Re: S.A. Dunn Construction and Demolition Landfill and Mine
DEC No.4-3899-00006

CITY OF RENSSELAER
SUPPLEMENTAL COMMENTS ON S.A. DUNN
CONSTRUCTION AND DEMOLITION DEBRIS
LANDFILL AND MINE

**DUNN C&D LANDFILL
IMPACTS ASSESSMENT**

November 10, 2022

DUNN LANDFILL ACCESS
MAP 1

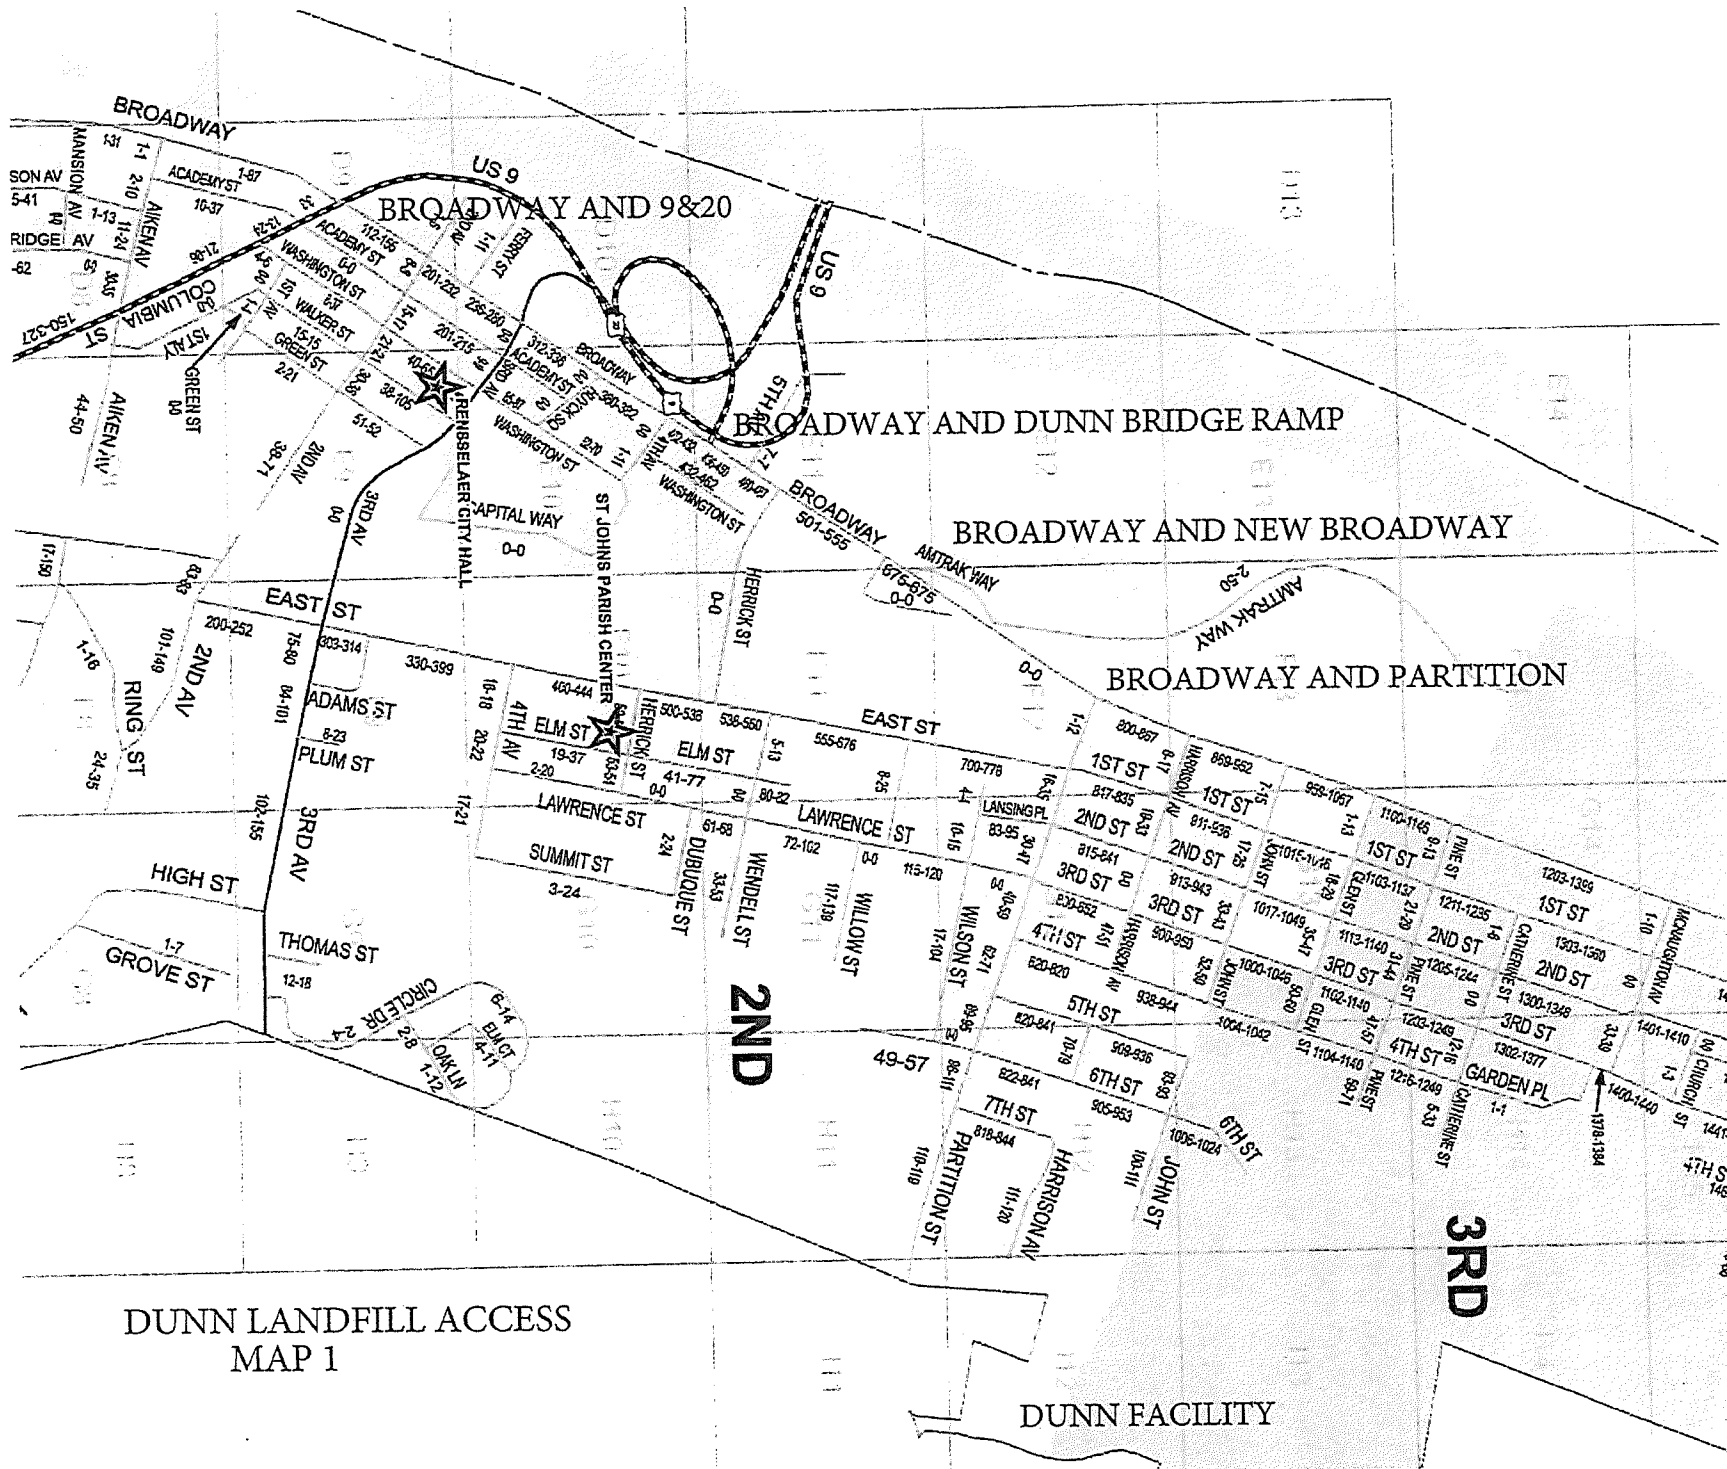
The facility is located off of Partition Street and uses the following access routes (See Map 1):

- 1) NYS Routes 9&20 from the east to Broadway, right on Broadway with a right turn at New Broadway and then a right turn at Partition. Then along Partition Street to the site access road.
- 2) NYS Routes 9&20 from the west (Dunn Bridge) to Broadway, left on Broadway with a right turn at New Broadway and then a right turn at Partition. Then along Partition to the site access road.
- 3) From I-787 via the Dunn Memorial Bridge to the Broadway access ramp to Broadway, left on Broadway with a right turn at New Broadway and then a right turn at Partition. Then along Partition to the site access road.

9820 AND BROADWAY DUNN ACCESS MAP 2

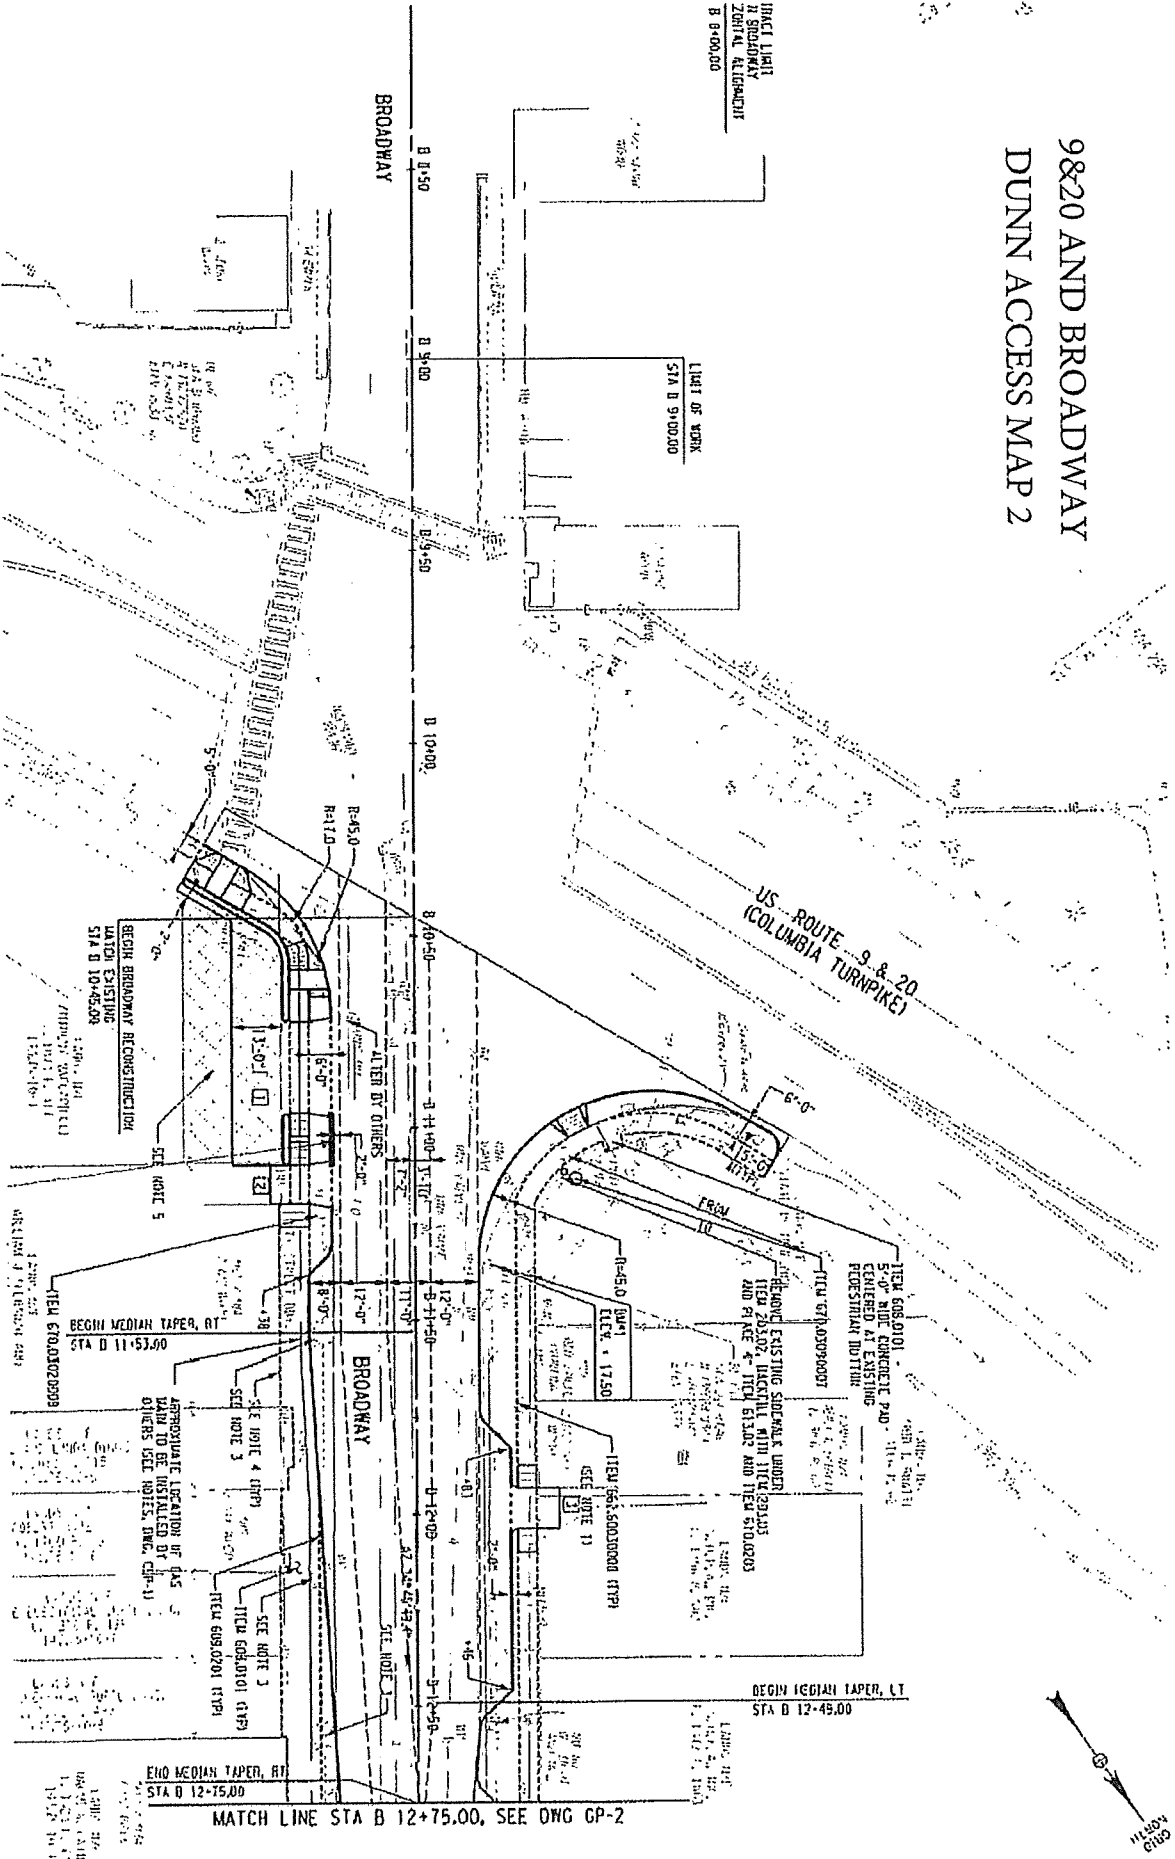
This is a fully signalized four way intersection with 9&20 going east and west and Broadway going north and south. Broadway south of 9&20 is truck and weight restricted. Access to the Dunn site is via Broadway and Partition Street (see Map 2).

Of the four intersections observed this one appears to operate the best. The outbound turns both east and west seem to work pretty well. The inbound turns have some issues mostly depending on where other traffic stops. If other traffic is at or passed the stop bars these turns become problematic. It was observed that other traffic in some instances had to back up to allow these turns.

BROADWAY AT DUNN BRIDGE RAMP DUNN LAND FILL ACCESS MAP 3

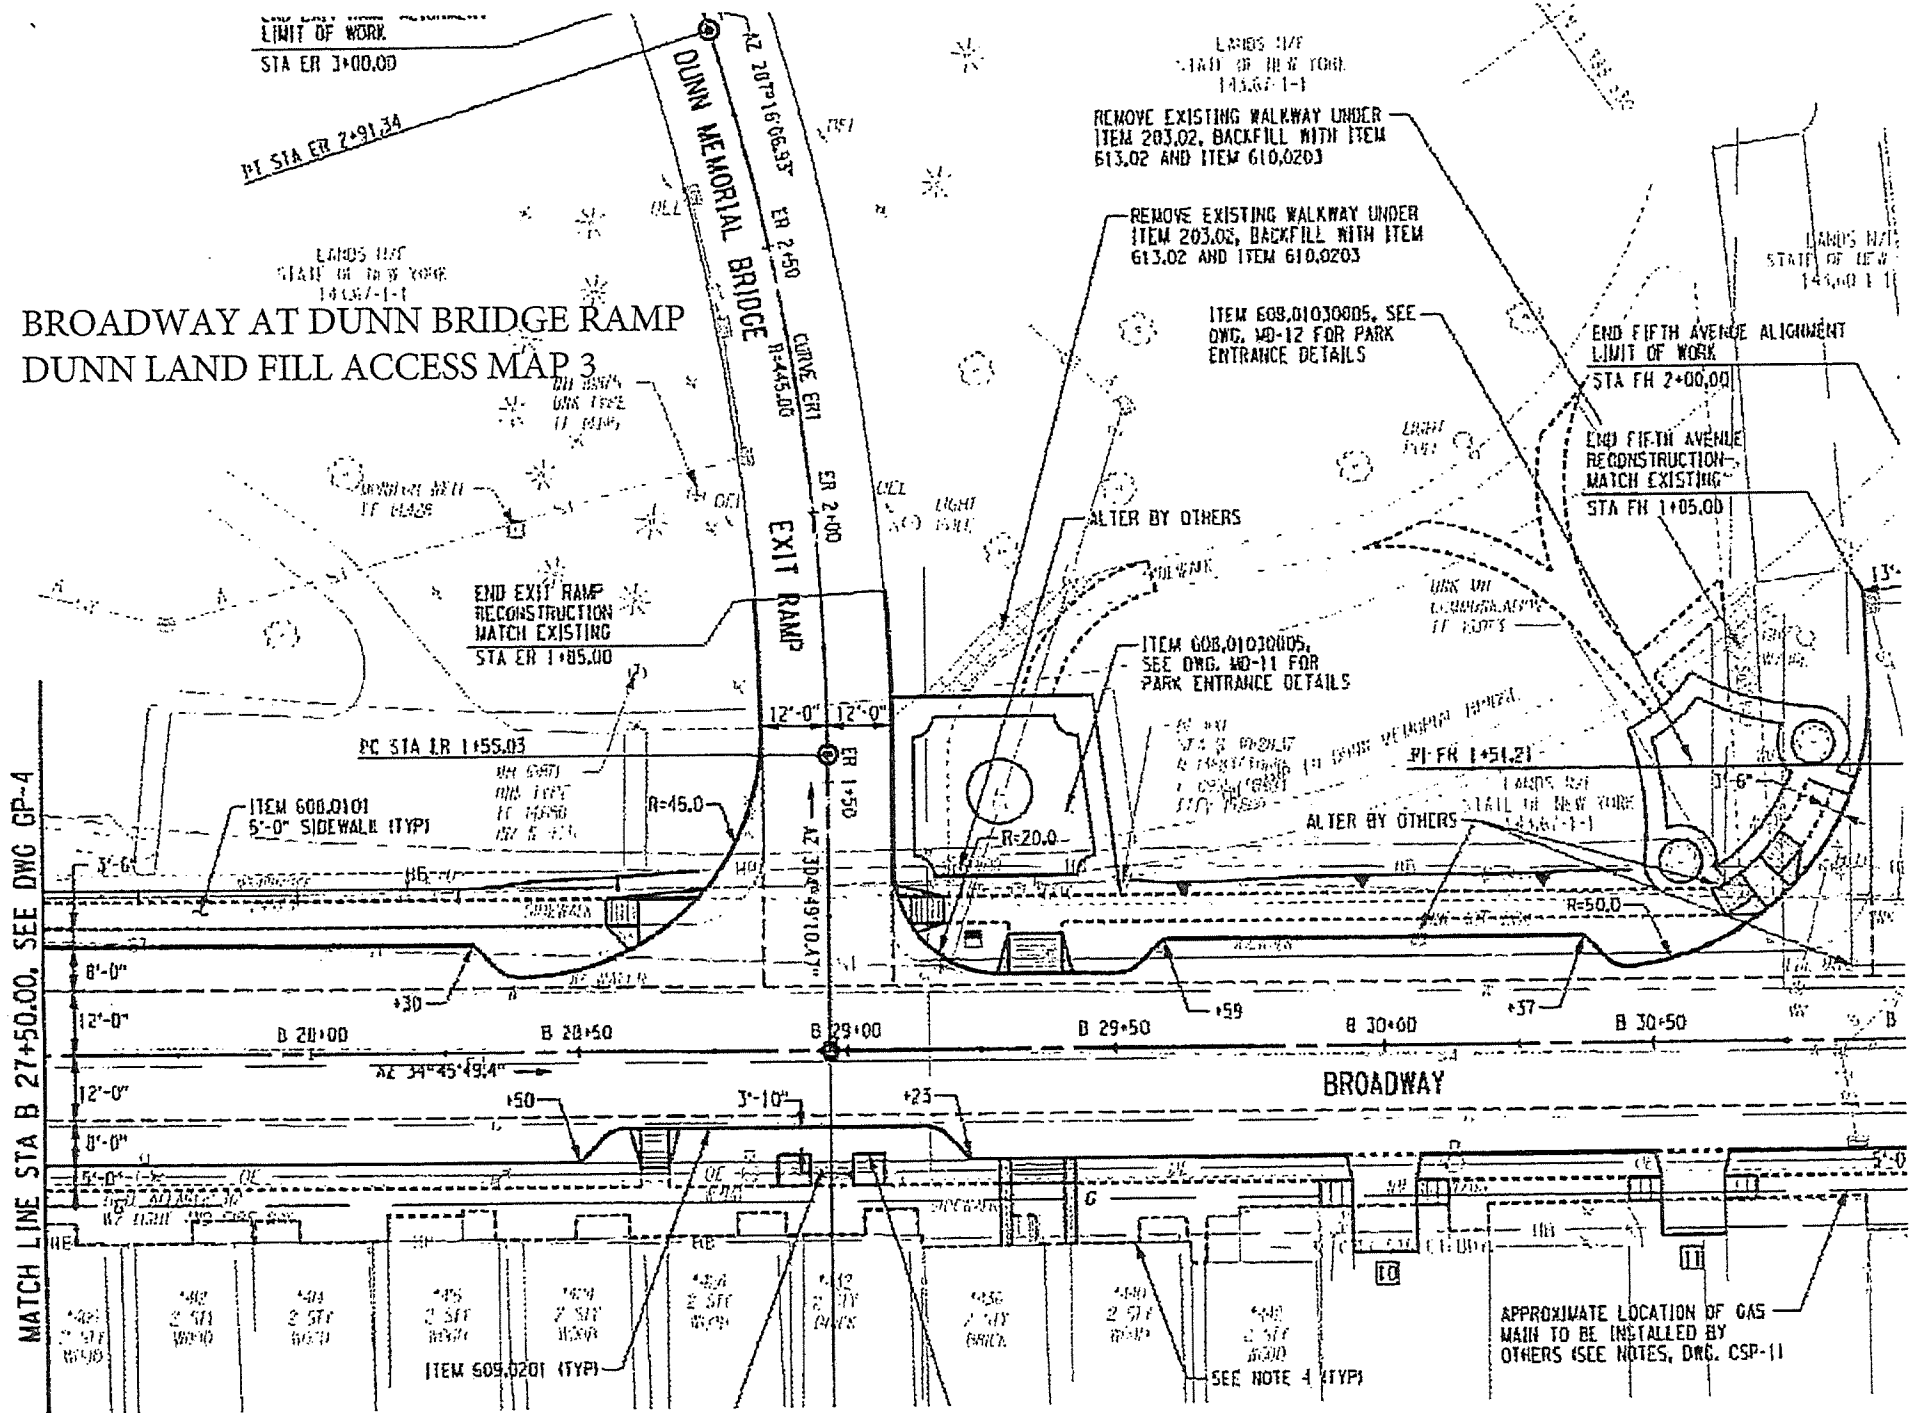
This is a fully signalized three way intersection with Broadway going north and south and the Dunn ramp providing access to Broadway for east bound traffic (see Map 3). The ramp provides access off of the Dunn Memorial Bridge which connects directly to I-787 on the west side of the Hudson River and terminates on the east side. The ramp as it approaches Broadway has both a left and right turn lane. This route seems to be the one most used by tractor trailers accessing the Dunn Facility.

Of the four intersections observed this one operates the worse and presents the most safety concerns. Most of the tractor trailers observed exit down the ramp and move directly into the right turn lane, either partially or completely, to make the left turn (see photos 1-4). On some occasions it was observed that other traffic coming down the ramp and making left turns continues along beside the truck making a left turn which makes for a dangerous situation when both try to turn left at the same time. If the truck does stay in the left turn lane they need to move dramatically into the right turn lane when they start the turn (see photos 5-8). This endangers traffic legally in the right turn lane. It does not appear that any left turn movement can be made if they stay completely within the left turn lane. If they try they ride up onto the
